JONES & HERRIN

August 4, 1997

Re: 1829 Gorgas House Museum, The University of Alabama

PORTICO N.E. CORNER

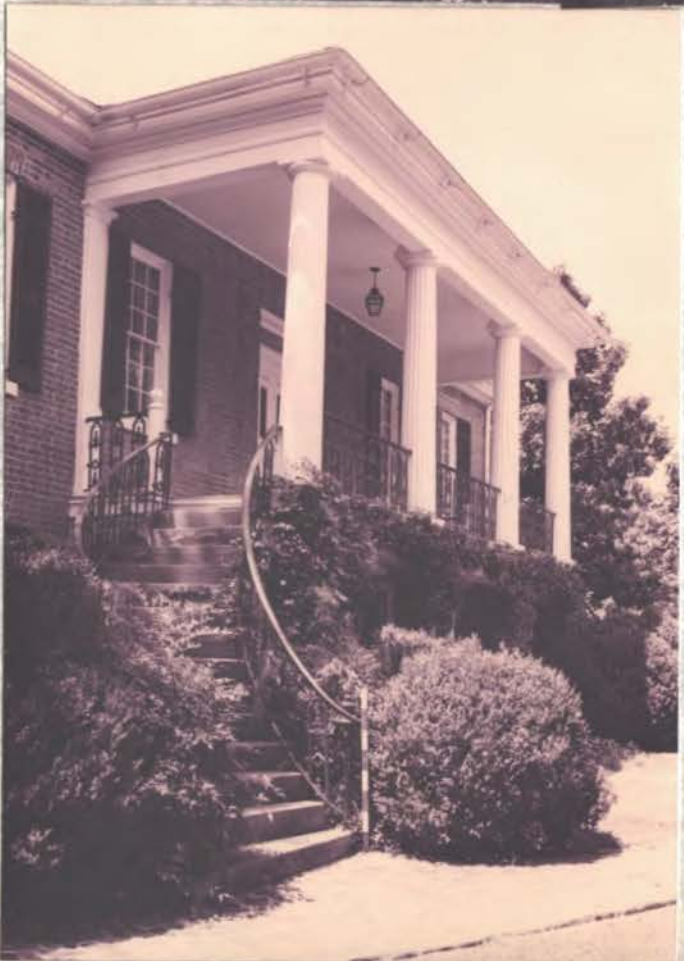
MODERN WALK, IN FRONT OF HSE
SOLV. BRICK
INCORRECTLY LWD
(WIDE STS.)
PORTLAND CEM. IN STS.
BASKETWEAVE PATTERN

ALL = INCORRECT. SHOULD BE
TIGHT STS. W/O MORTAR (SAND-FILLED STS)
TYPICALLY 45° HERRINGBONE PATTERN
LWD IN SAND-BED (NO CONC.)

HEAVY sandblasted brick prior
at lower part of portico

MOD. BRICK PAV.
INCORRECT PATTERN
SHOULD BE
(LIKE ORIG.
HEBERT
IN FL. 2
N.E. RM)
E MBW OTHER
AL. 1974. C.
EXAMPLES

W. REAR

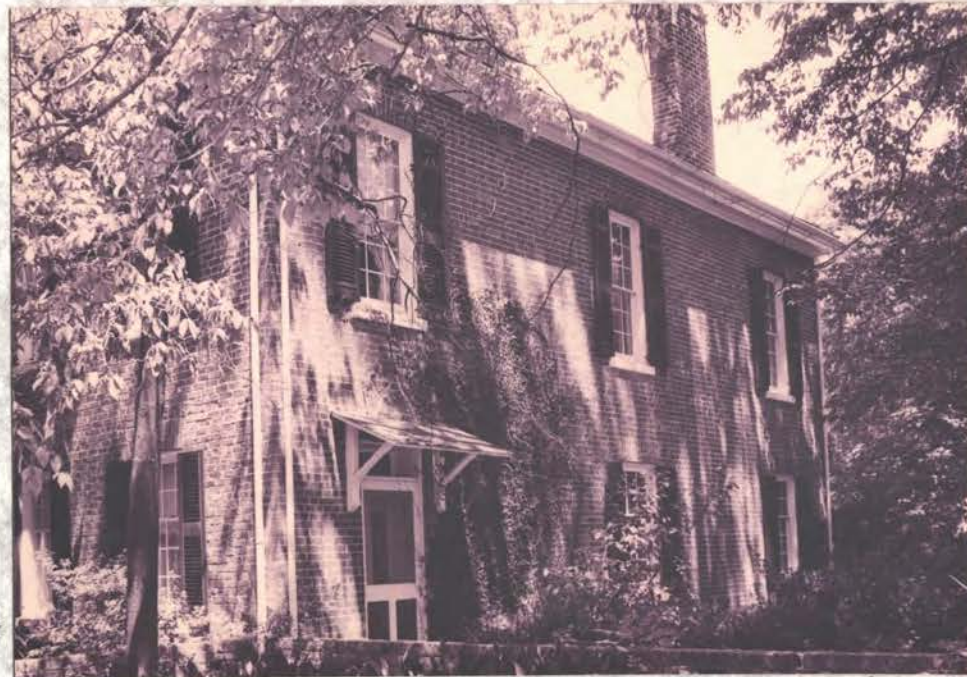
Note hidden gutters (late mod. slung half-rnd. at front) ARE COVERED IN 1997

later shed, vic. door (was P.O. at a time)

poor drainage in S. yard

N.W. CHIM. (rebuilt w/ salvaged salmon bricks
thru a portland cem. mortar)

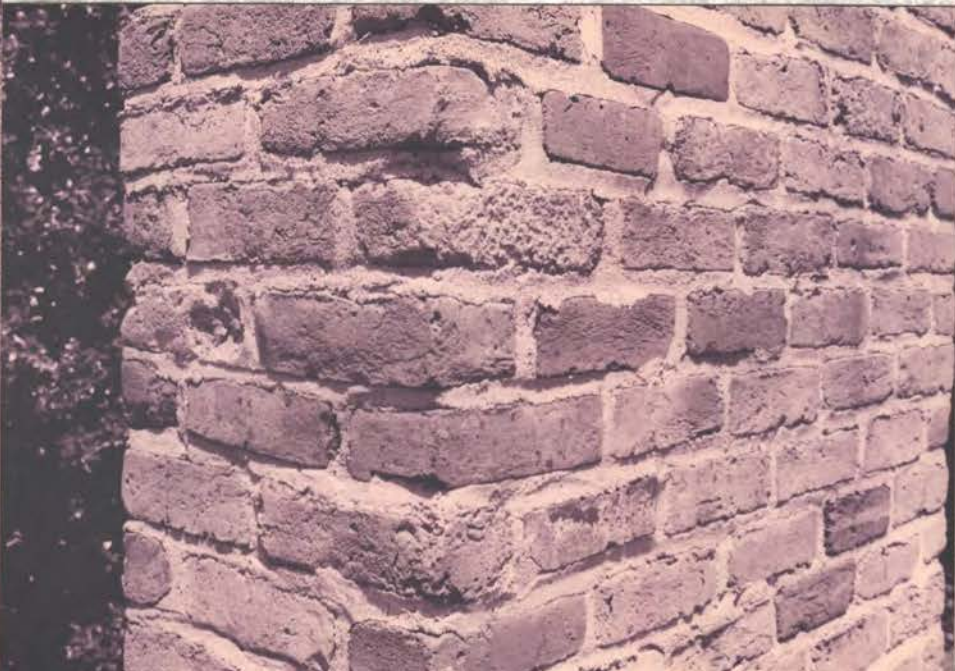
N ← N.W. CHIM.
rusty metal cap

N ← rusty galv. flash
ALL CHIMNEYS LEAK
DOWN INTO ATT.

portland com mortar, cracks

c. 1984 std. wt. (14 g. r. ±) compos. shingles
rusty galv. met.
